Inspection Report

Permittee: **GENWAL RESOURCES INC**
 Operator: **GENWAL RESOURCES INC**
 Site: **CRANDALL CANYON MINE**
 Address: **PO BOX 910, EAST CARBON UT 84520-0910**
 County: **EMERY**
 Permit Type: **PERMANENT COAL PROGRAM**
 Permit Status: **ACTIVE**

On March 14th, 2013, a partial inspection of the Crandall Canyon Mine facility was conducted by Division of Oil, Gas and Mining (the Division) staff member Steve Christensen. The purpose of the field inspection was to document the status of the mine-water discharge pipe and water treatment system following a rock fall event that occurred in the early morning of March 13th, 2013.

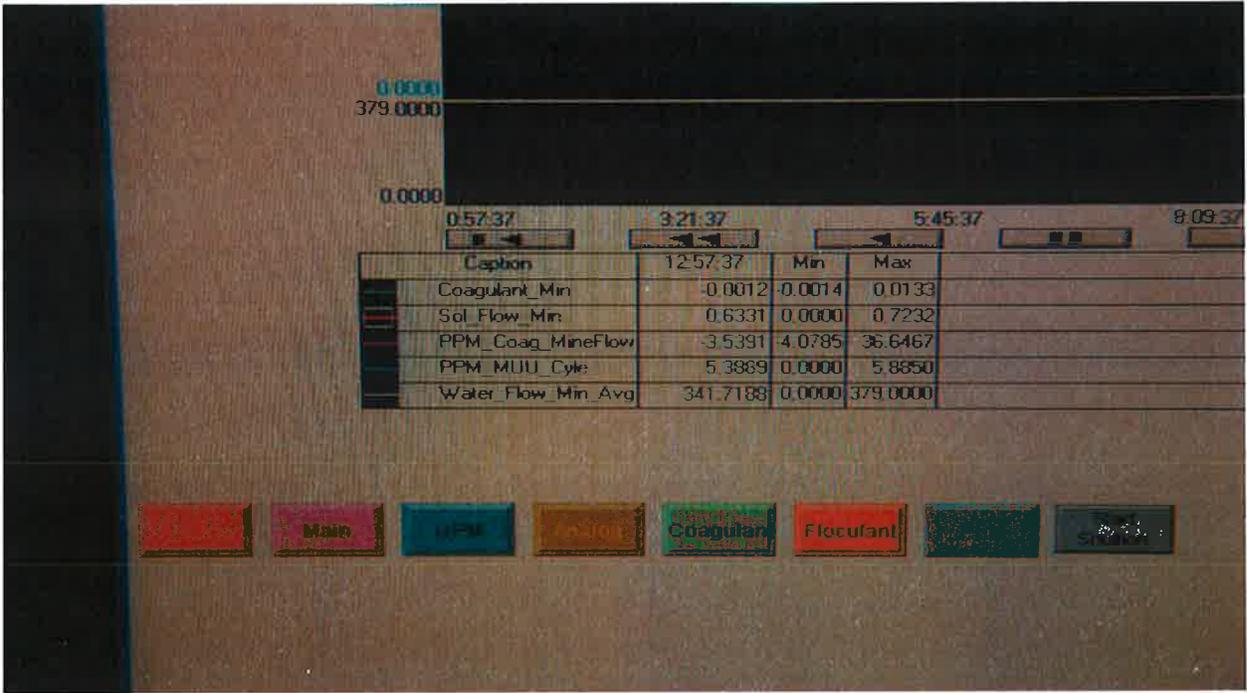
Due to the rock fall, the newly established sample port was broken and no longer operable (See photo). Company representative Dale Davis indicated that the old sample port located in the treatment shed would be utilized until such time as a new sample port can be re-established.

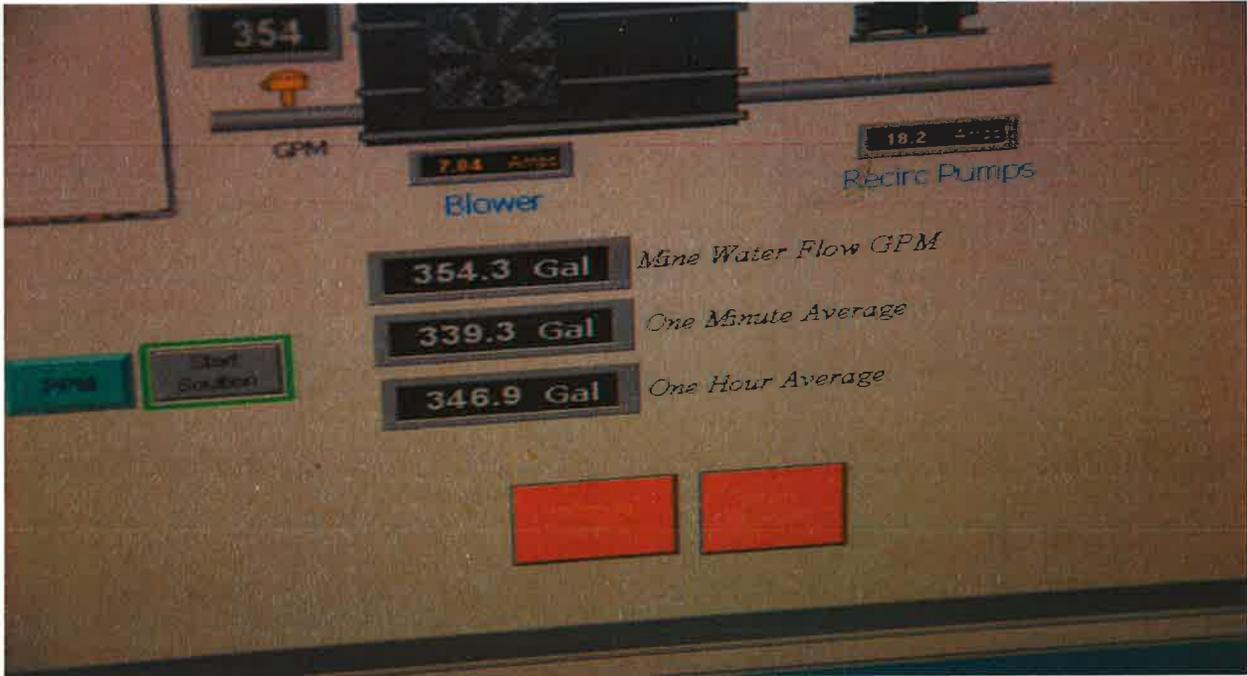
The primary sediment pond for the Crandall Canyon mine site was inspected during the field visit. The two sediment markers were inspected. Due to the water level in the pond, the sediment markers were not visible (See photo).

The 10-year, 24-hour design storm event marker was also inspected (See photo). At the time of the inspection, there was approximately 1-2" of snow in the area of the design storm event marker. However, no portion of the marker was visible indicating that the water level in the sediment pond is at or above the design storm event elevation.

As a result of the observations discussed above and upon review of the approved design considerations for the Crandall Canyon sediment pond, NOV #10105 was issued to the Permittee on March 18th, 2013 for failure to maintain adequate storage capacity within the primary sediment pond. The Permittee has until May 4th, 2013 to address the abatement requirements of the NOV.
